**ZP-24-87; 63 Lakeview Terrace (RM, Ward 2) Barbara Zucker / Louis Lionni / Joe Fisher
Proposed two-story addition with basement and elevator. (Project Manager, Scott Gustin)**

MEMORANDUM

To: Design Advisory Board
From: Scott Gustin
Re: 63 Lakeview Terrace
Date: May 14, 2024

Request: Proposed 2-story rear addition to existing single family home.

A201

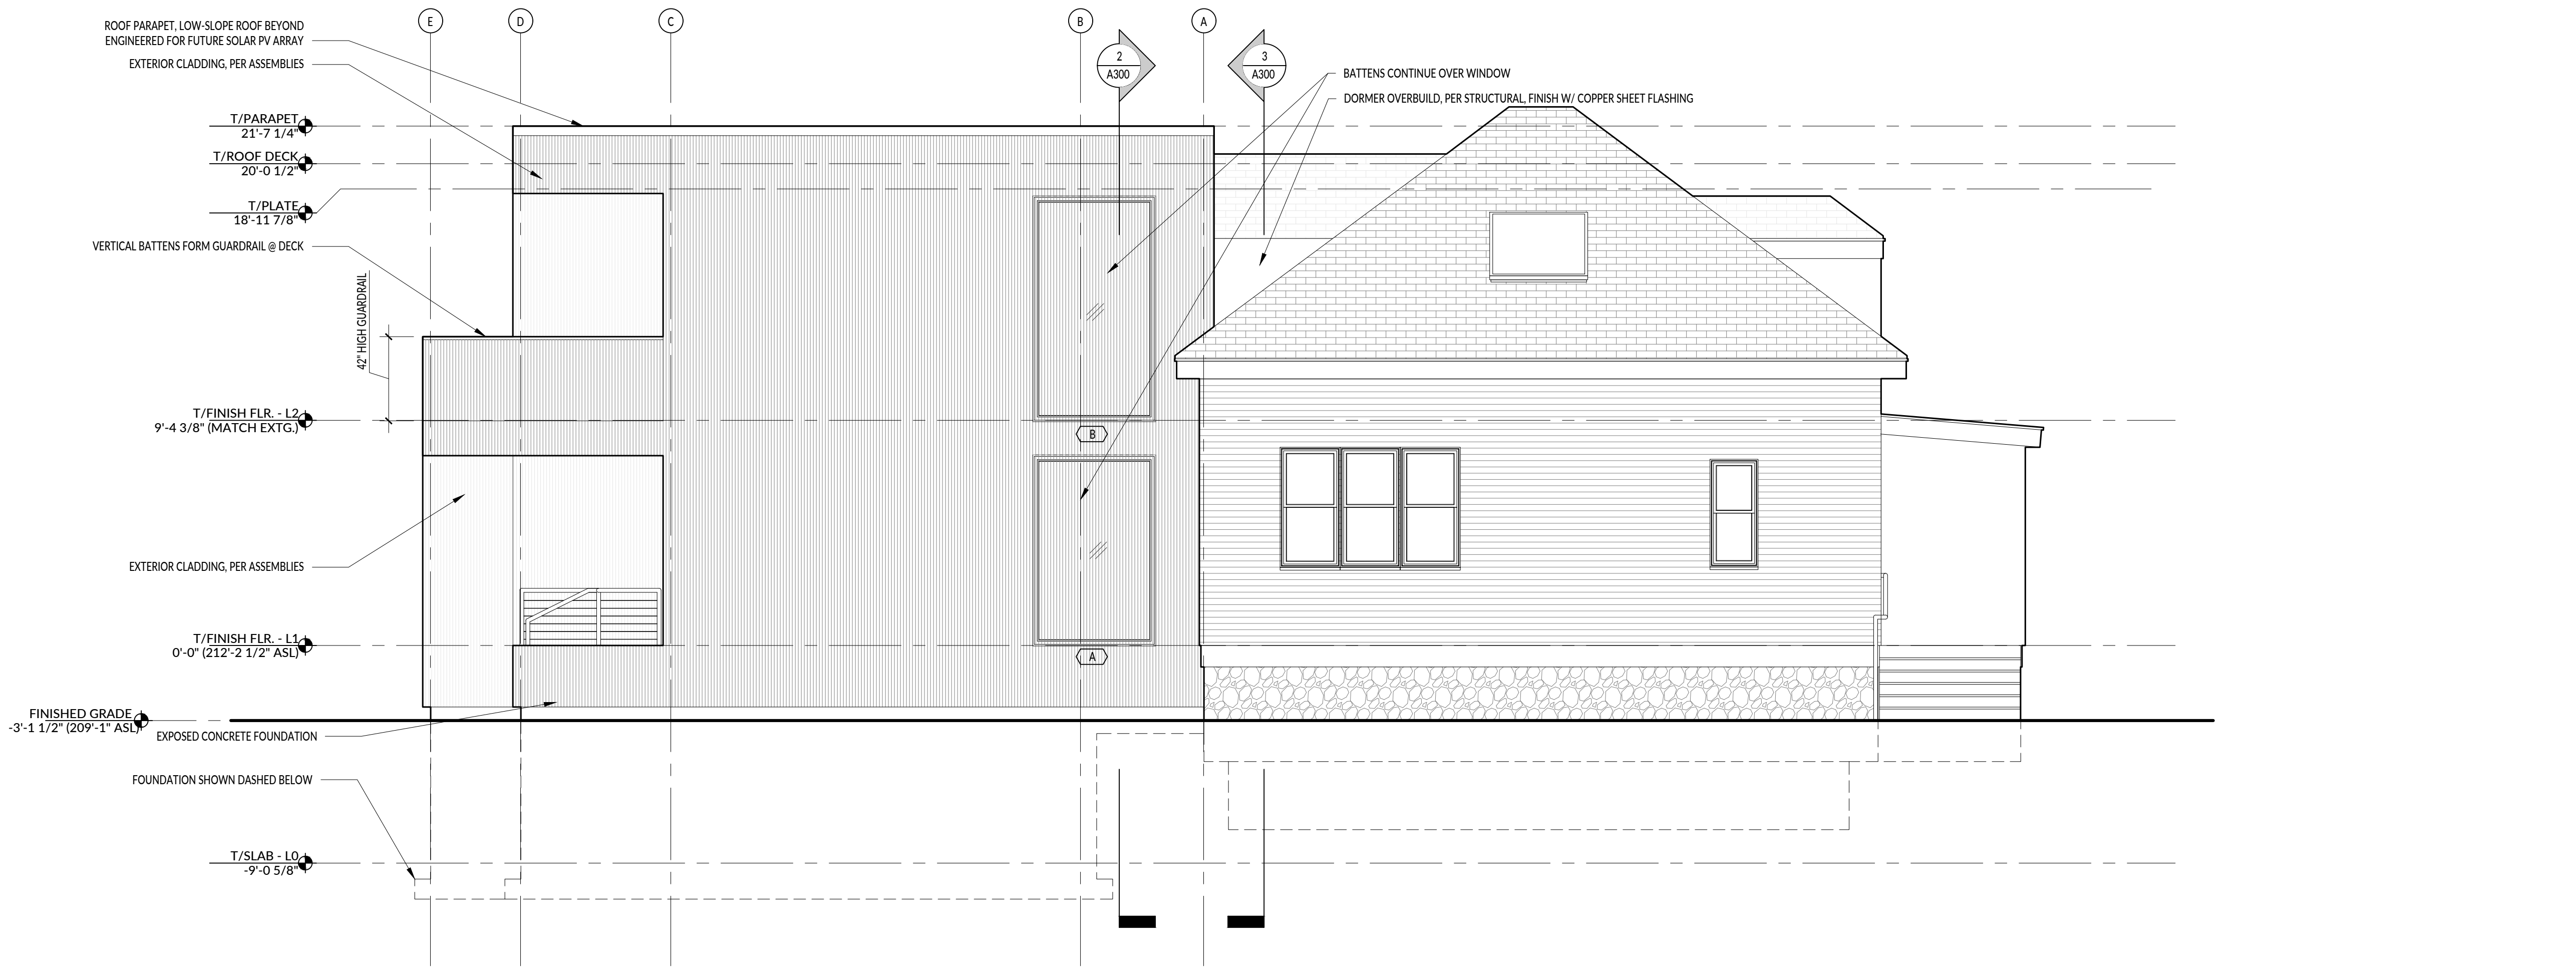
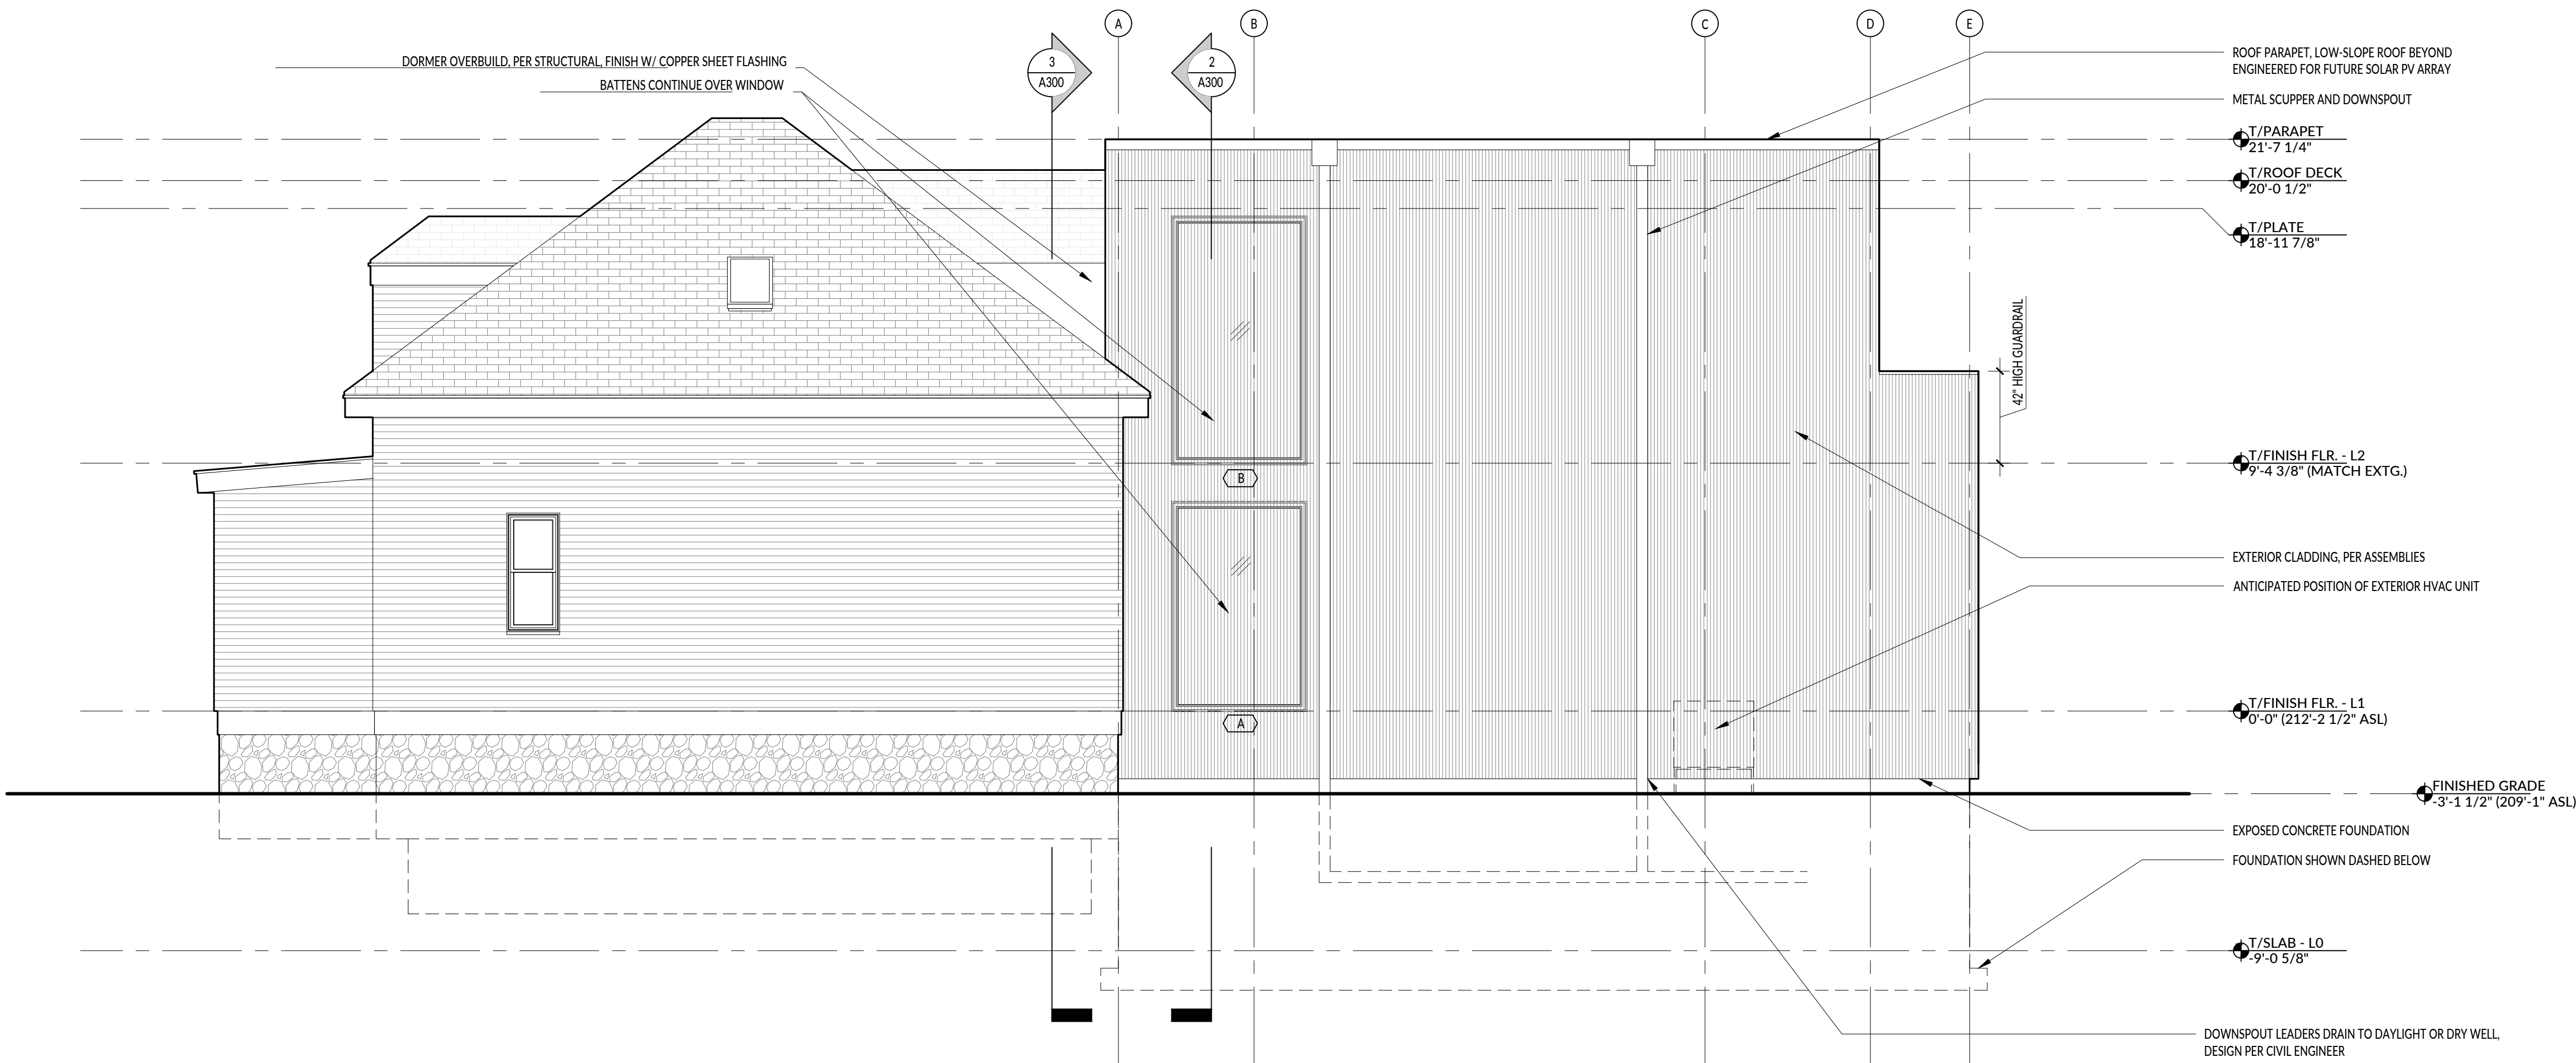
The elevation plans include notation that the addition roof will be constructed to support a future solar array. The property appears to be well situated for solar energy capture, and installation of such array is encouraged.

New outdoor lighting is included in this application. Some fixture information is provided in the project details that depict a canister fixture and a step light. No illumination information is evident, nor is fixture location shown. The fixtures are likely acceptable; however, lumen information is needed to determine compliance with Sec. 5.5.2, *Outdoor Lighting*, and fixture locations need to be depicted on the project plans.

As with the rest of the addition, proposed fenestration is a departure from that in the original home. Both side elevations include large windows screened behind the siding battens. As noted above, the western elevation contains ample glazing to take advantage of expansive views across the downtown waterfront and beyond. The proposed fenestration appropriately contributes to the design of the addition.

The addition will make use of existing utilities serving the property. No roof-top equipment is evident. Two exposed downspouts are located along the northern elevation and will be painted to match the siding.

1. Provide additional detail as to vegetation removal and new vegetation installation, including the extent of vegetation to be removed and species and size of new plantings.
2. Provide outdoor lighting fixture locations and lumen levels.
